## PLANNING STAFF REPORT

**SUBJECT:** *Alton Glendenning Subdivision - Plan 2024-1 - Miramichi Bay - Parish of Hardwicke*

**MEETING DATE:** April 16<sup>th</sup>, 2024

**AGENDA ITEM:** 2024-3-3

**TENTATIVE SUBDIVISION PLAN**  
**ALTON GLENDENNING**  
**SUBDIVISION**  
 PLAN 2024-1  
 MIRAMICHI BAY  
 PARISH OF HARDWICKE

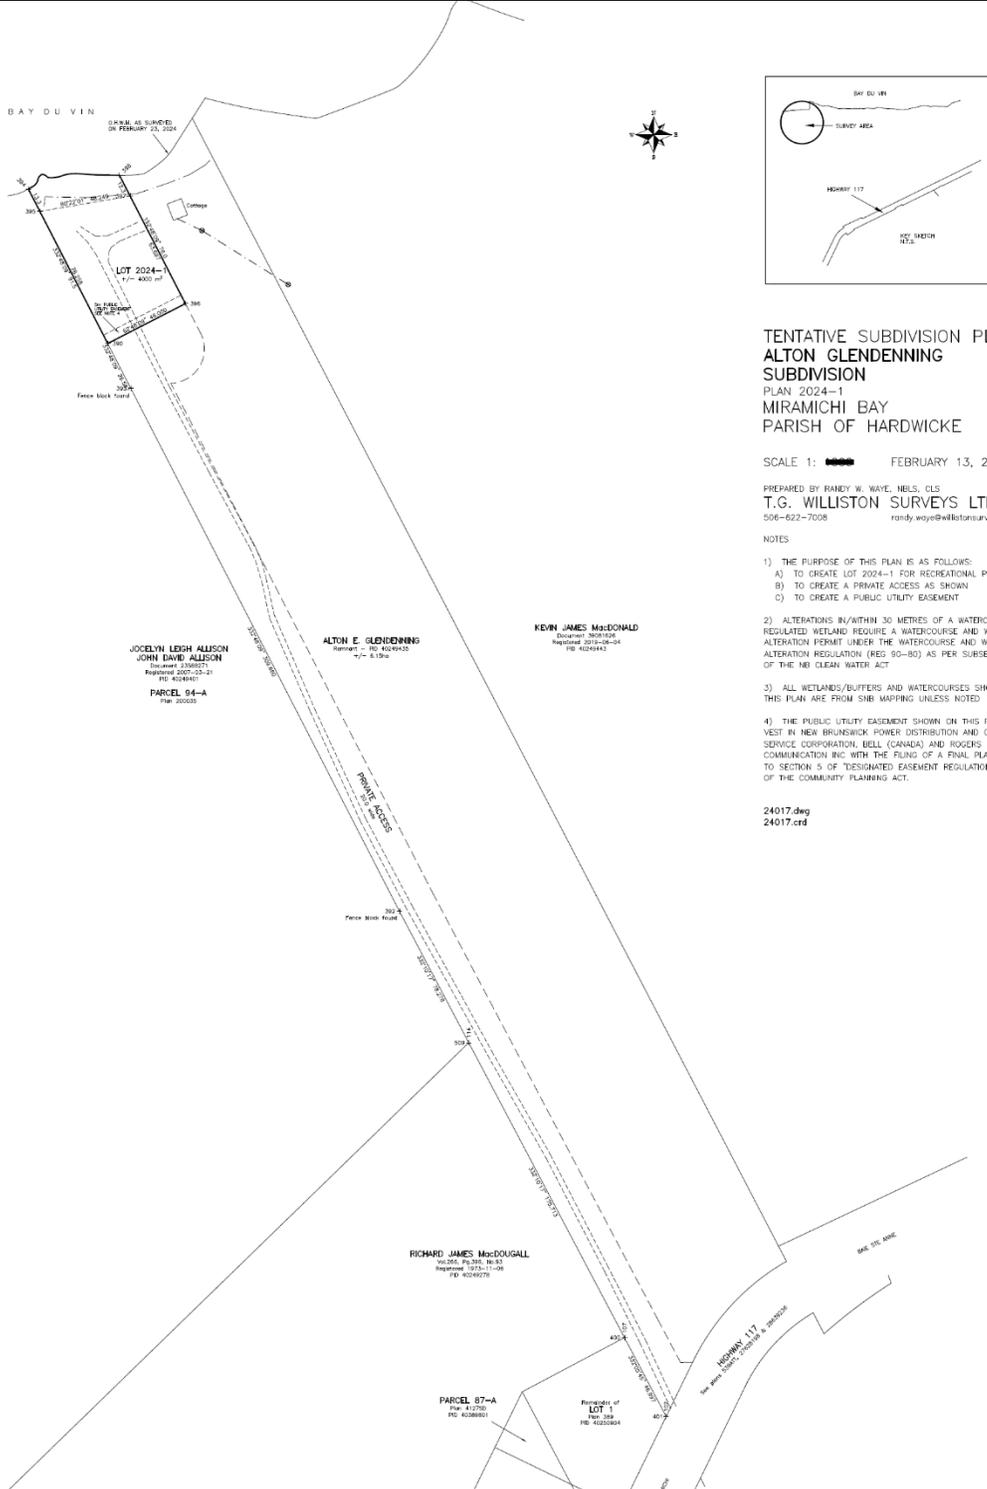
There is already an existing private driveway located over the proposed private access which provides the dwelling access to Route 117, but the private access is required to permit Lot 2024-1 to connect to Route 117, a provincially owned public road. The private access measures 20 metres wide throughout its length but has a wider opening on Route 117 to facilitate entry and an 18-metre radius turnaround at the dead-

end portion as suggested in Part B Section 1.1(f) of the GMRSC PRAC's *Policy for Private Accesses*. The final plan will need a note mentioning that the Department of Transportation and Infrastructure (DTI) will not upgrade nor maintain this private access and that the property owner is responsible to look after these. As well, the developer shall be advised that the access should be designed to support the expected loads imposed by firefighting equipment, other emergency vehicles, and private services vehicles such as for septic tank maintenance. Therefore, the access should be surfaced with concrete, asphalt or other material designed to permit accessibility under all climatic conditions.

The lot meets the required depth and area minimums as per Section 6(4) of the New Brunswick Regulation 80-159 under the *Community Planning Act* (c.19), but not its frontage on the access. Measuring only 46 metres wide, a variance of 8 metres is needed to meet the minimum 54-metre width requirement.

A subdivision assessment report (soil test) is also required considering that this lot has less than 8,050 square metres (*New Brunswick Technical Guidelines for On-site Sewage Disposal Systems*, Appendices B and B1). As for the remnant of PID 40249435, it retains just over 6 hectares.

A subdivision inspection report (sight distance) is not necessary since the existing driveway already intersects Route 117. The allowed speed for this section of said route is limited to 80 kilometres per hour which would have required a sight distance of 140 metres.

1. A variance of 8 metres for Lot 2024-1 from the required 54-metre minimum width; and

subject to the submission of a subdivision assessment report for Lot 2024-1 and provided that the following notes be inserted on the final plan:

“The private access shown on this plan is not suitable for a public street. The Department of Transportation and Infrastructure will not upgrade or maintain this private access and all maintenance services and improvements to the private access are the responsibility of the property owner”; and

“The Planning Review and Adjustment Committee (PRAC) does not carry on-site inspections of the private access shown on this plan. Construction of a private access on this parcel of land in accordance with all relevant regulations, if any, is the strict and sole responsibility of the property owner or developer. The PRAC expressly makes neither representations nor warranties of any nature whatsoever that the condition and construction of the access is suitable for safe movement of vehicle traffic. The PRAC only approves the location of the access shown on this plan and not its condition and makes no representation nor warranties whatsoever with respect to the condition of the access.”
